Product Information (PI1261)

Halo Illumination Flange Color Change Series 84

Series 84 Halo Illumination Flange Color Change

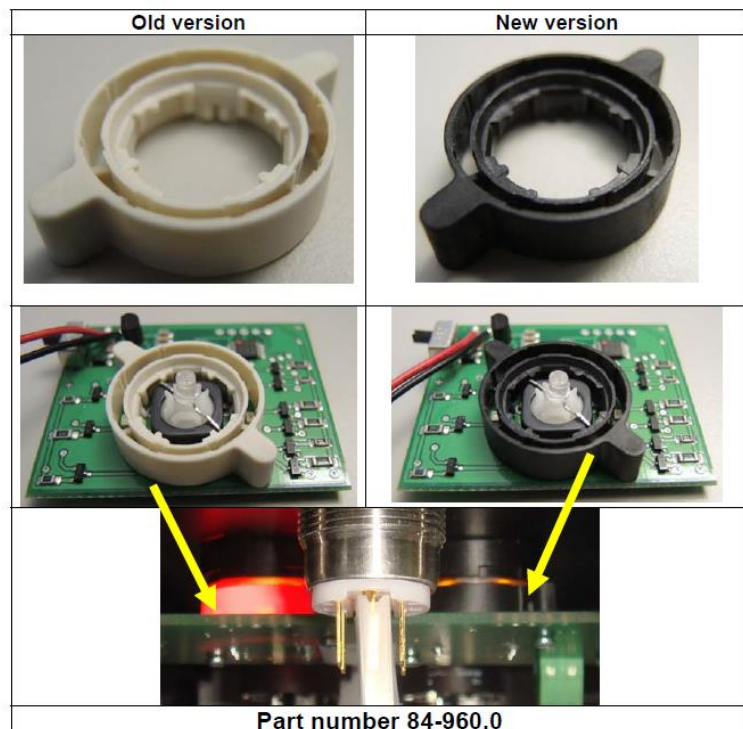
The Series 84 halo illumination flange will now be manufactured in black to reduce LED side-shine light bleed. There is no change in part numbers as both components are interchangeable. EAO part number 84-960.0 will remain valid. The new flange will be available from January 13, 2013.
